PCN – Process Change Notification

Change:	OMB.433.B03F21
Date:	2016/07/12
Author	Kim Ho

Model#	Part Number	Changes
433MHz 3dBi Omni Antenna with N Type Female Connector , U-Bolt 523mm Length Ø70*55mm	OMB.433.B03F21	Amend Aluminium tube brackets.

Old drawing

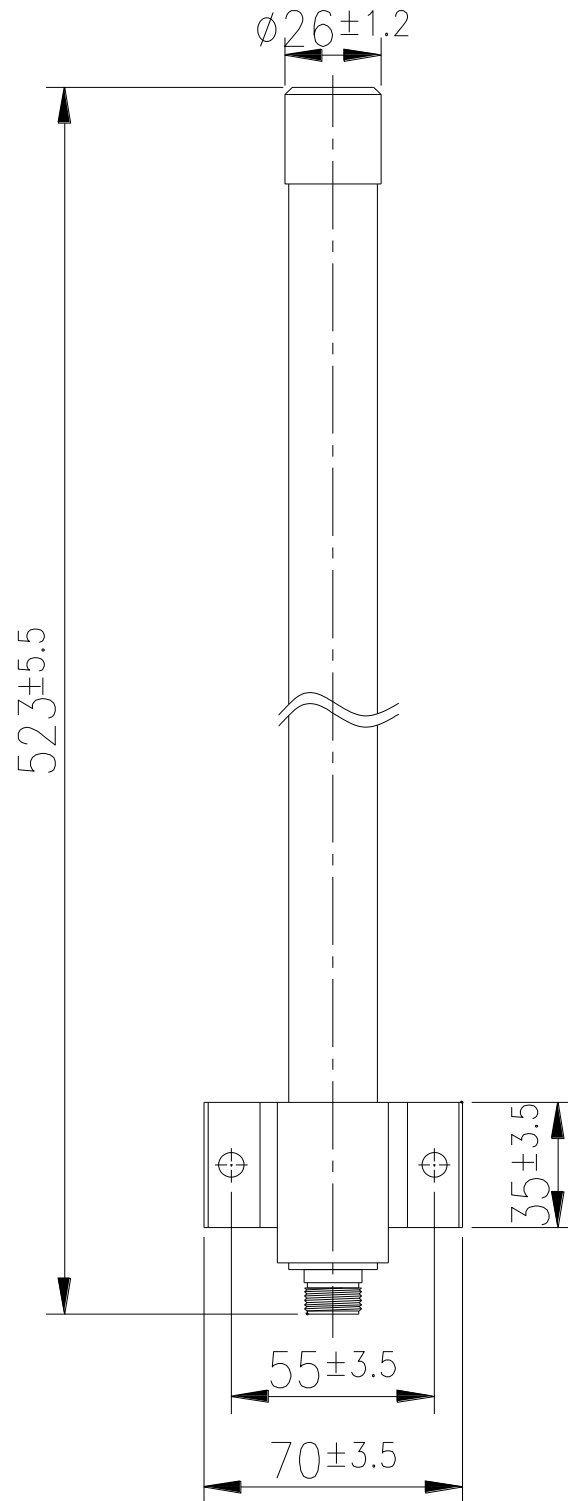
- Due to antenna performance, Aluminium tube brackets size need to amend from 35mm to 53mm. also change two mounting holes to four mounting holes.
